**LEGAL ADVERTISEMENT
HISTORIC PRESERVATION BOARD
CITY OF PORTLAND
Public comments are taken at all meetings.**

**PUBLIC HEARING
71 INDIA STREET**

TO: Chair Benson and Members of the Historic Preservation Board
FROM: Deborah Andrews, Historic Preservation Program Manager
DATE: May 11, 2017
RE: May 17, 2017 **PUBLIC HEARING**

Application for: Certificate of Appropriateness for Building Addition
Address: 71 India Street, addition to existing Amato's store
Applicant: Dominic Reali Realty LLC.
Architect: Evan Carroll, Bild Architecture

PHOTOS OF
AS-BUILT
CONDITIONS

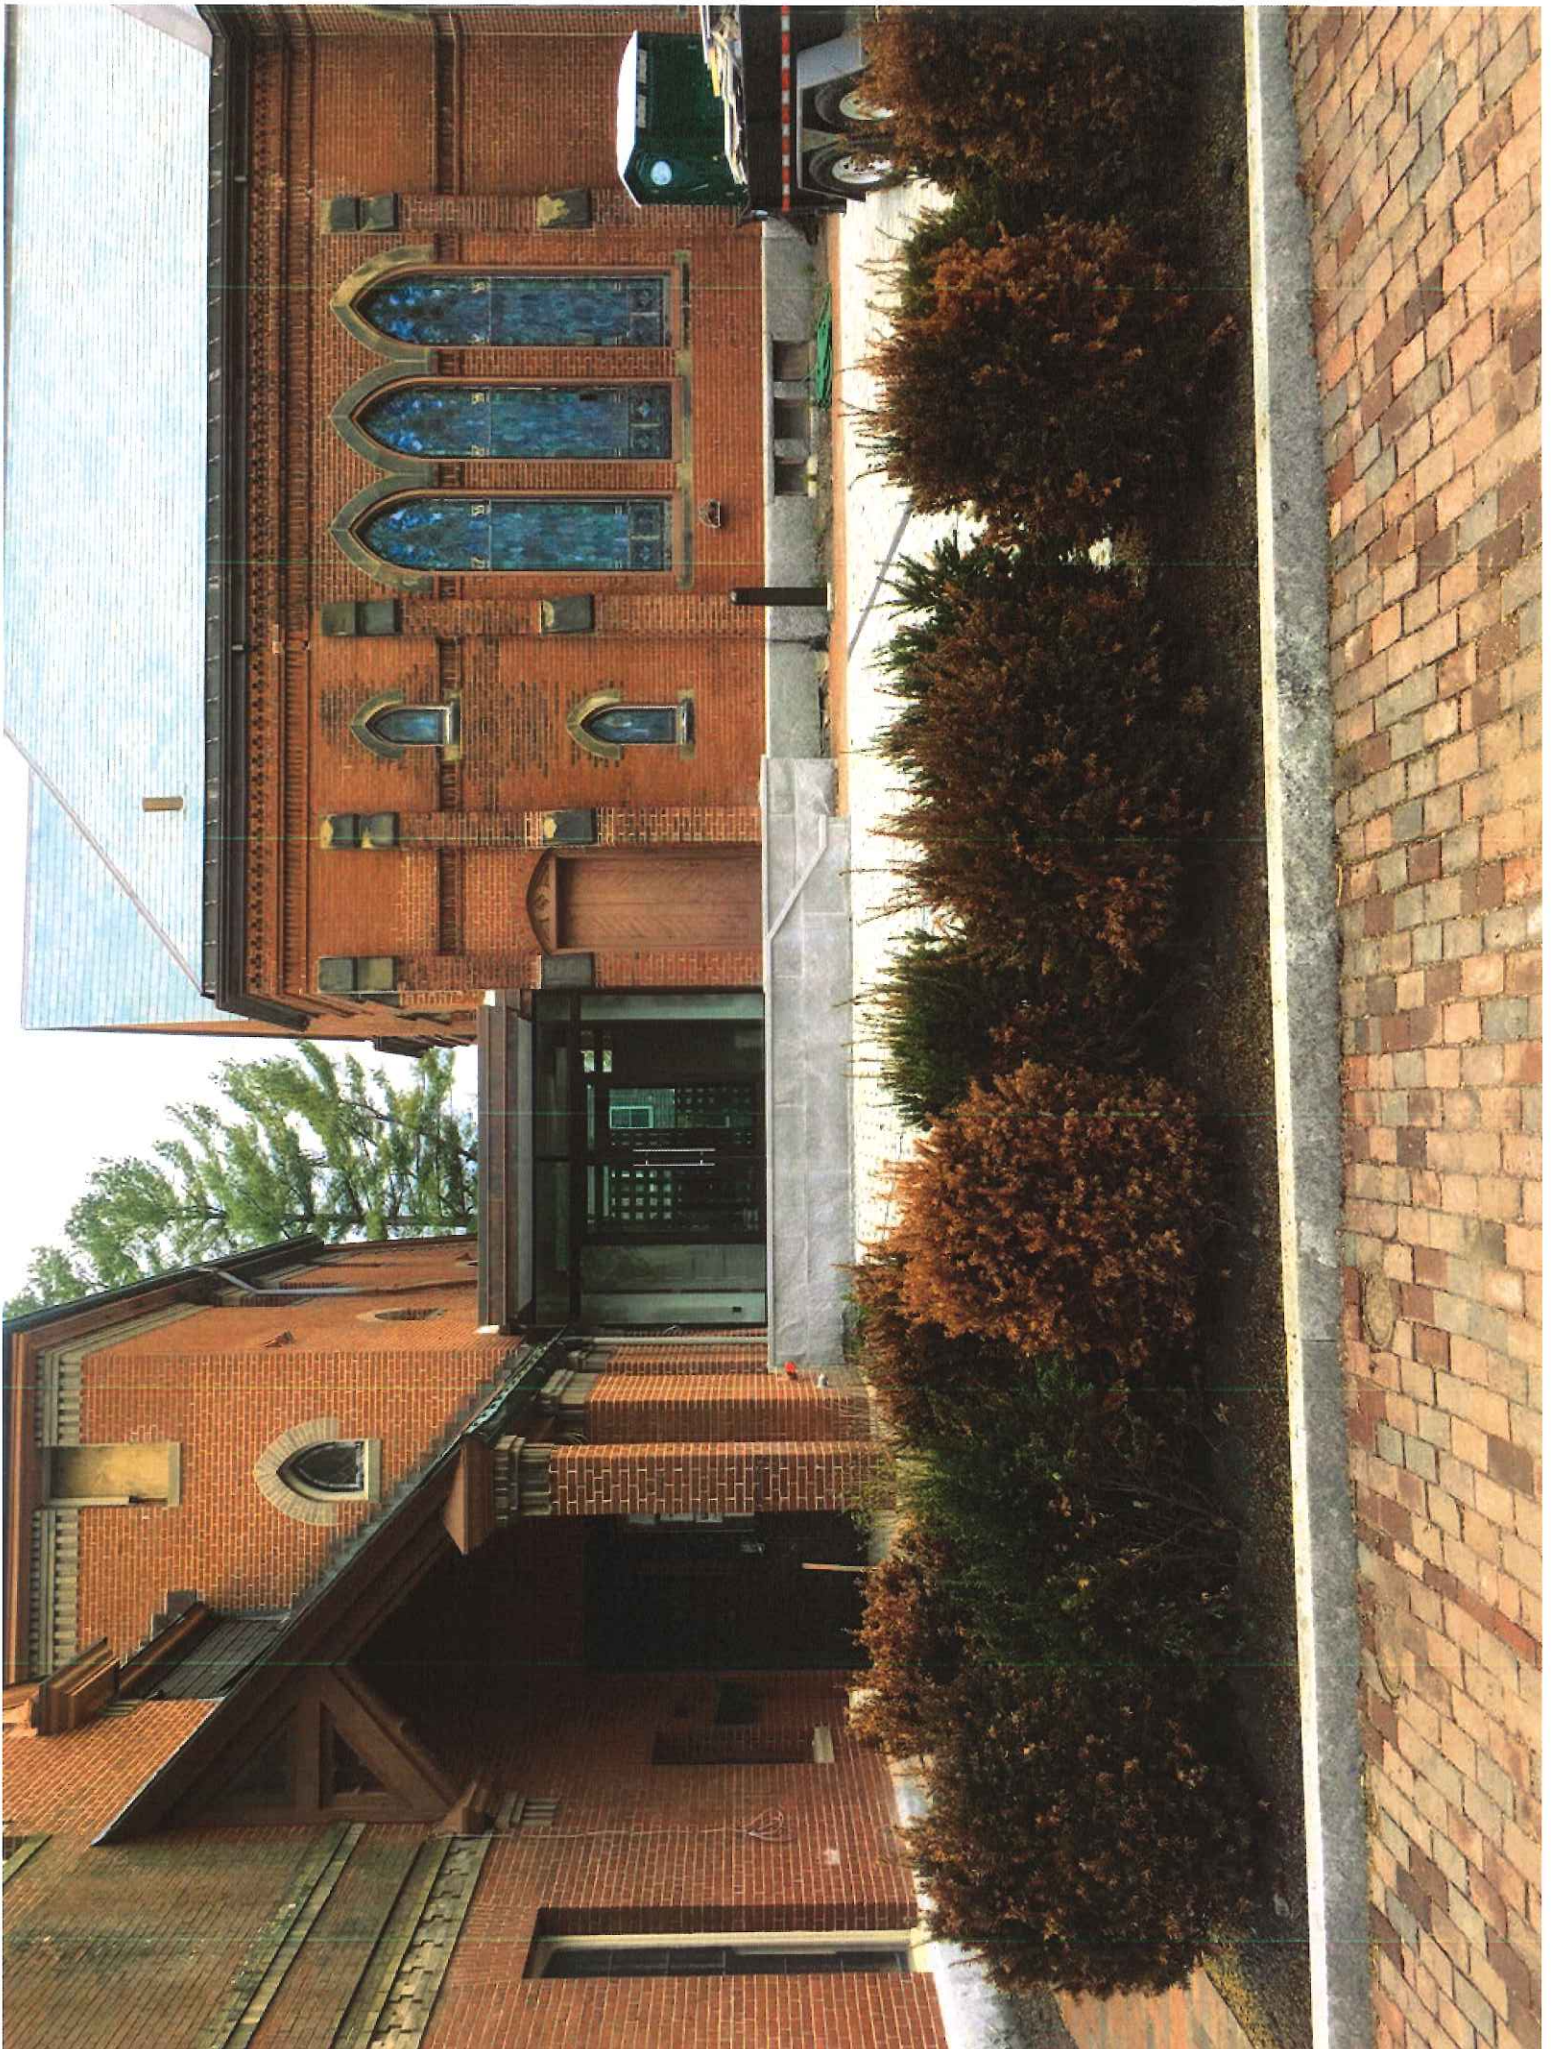
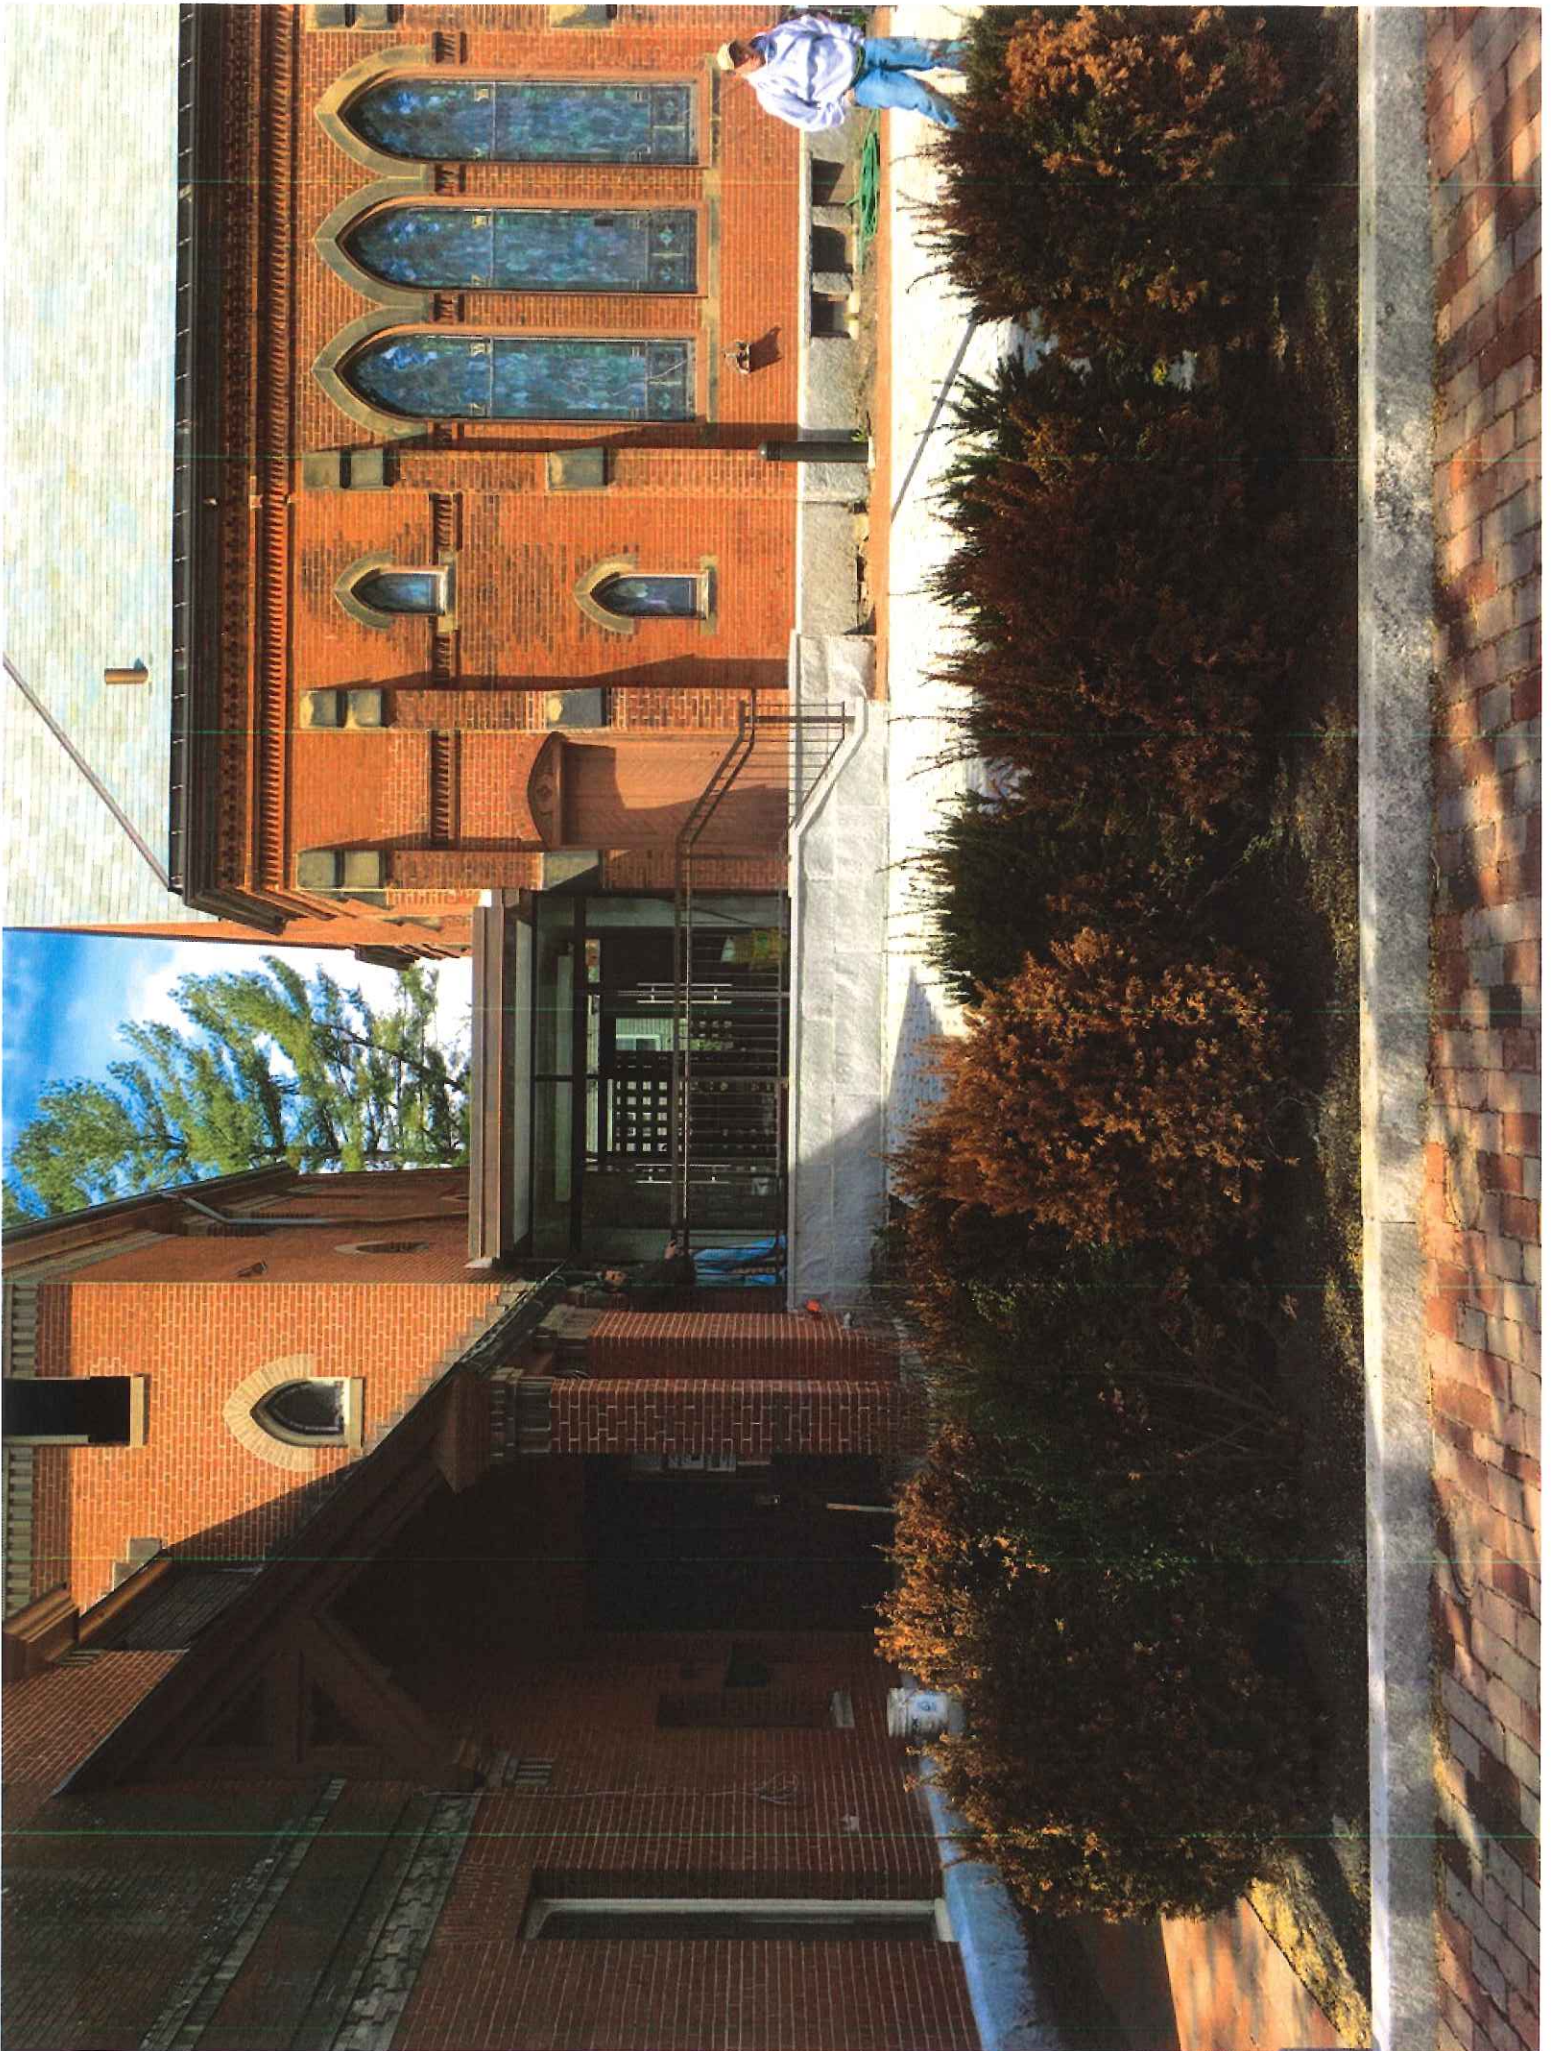
The revised railing was brought to the staff's attention by the contractor at the recommendation of the architect. When Mr. Winch was shown the railing by the general contractor in a site visit, he noted that it did not comply with the approved design and that he had not been provided a shop drawing for final sign-off prior to its fabrication. As built, the railing is 40 inches tall and all components of it feature square edges. The top rail, which was to be graspable in the original design, is squared off and is too high and too wide to meet code in terms of being graspable. To meet code requirements, the fabricator added a lower, graspable handrail inside the railing system at 34" above grade. The entire assembly is bronze anodized aluminum.

In his letter, Mr. Winch describes the circumstances that led to the deviation from the approved plans. The concerns described in the letter do not explain the change in the design itself (which now includes a transom) or the different hardware finish. The decision to change the entry system was made by the project team without advance notice or approval from city staff.
